**SAN ANTONIO WATER SYSTEM  
SCHNEIDER TRACT 24" CIP APPROACH WATER MAIN**

**SAWS JOB NUMBER 15-1072  
SOLICITATION NO. CO-00046**

**ADDENDUM No. 2  
FEBRUARY 4, 2016**

## STREET CUT REPAIR DETAIL

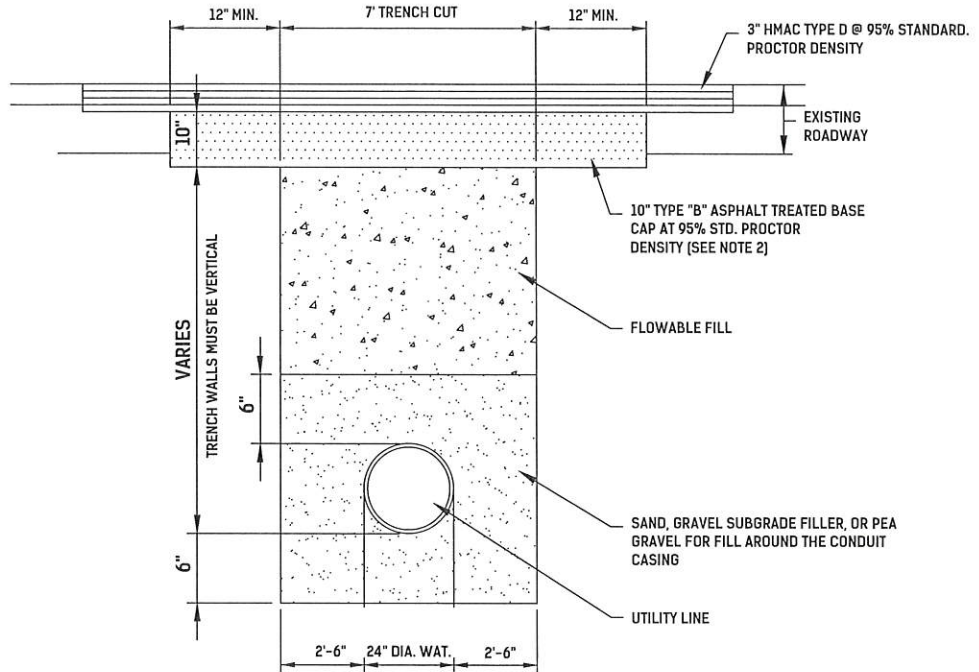
1. *Add the supplemental exhibit "Street Cut Repair Retail", Sheet No. E-1. See enclosed attachment to this Addendum No. 2.*

1. THE LIMITS OF THE PAVEMENT REPLACEMENT ARE DENOTED ON DETAIL "A" THIS SHEET, AND MUST BE SAW CUT STRAIGHT. TACK OIL AT A RATE OF 0.10 GAL/SY SHALL BE PLACED PRIOR TO PLACEMENT OF 2" HMA TYPE "D" FINISHED SURFACE.

2. A 10" THICKNESS OF TYPE "B" ASPHALT TREATED BASE, BENCHED A FEET EACH SIDE OF TRENCH, WILL BE USED FOR THE FINAL LIFT OF THE TRENCH REPAIR. THE ASPHALT TREATED BASE, PLACED IN 5" LIFTS, SHALL BE BROUGHT UP TO WITHIN 2 INCHES OF THE EXISTING PAVEMENT SURFACE.

3. THE UTILITY COMPANY WILL BE RESPONSIBLE FOR THE MAINTENANCE OF THE STREET CUT THEREAFTER UNTIL AND IF THE COUNTY REMOVES THE STREET CUT THROUGH RECONSTRUCTION.

4. WHEN GEGRID OR OTHER GEOSYNTHETIC SUBGRADE/BASE REINFORCEMENT IS PRESENT, THE CONTRACTOR SHALL CONDUCT EXCAVATION TO PROVIDE APPROPRIATE OVERLAP (2' MIN) AND TIE TO EXISTING UNDISTURBED REINFORCEMENT AS REQUIRED BY MANUFACTURER FOR EACH LAYER OF REINFORCEMENT ENCOUNTERED.
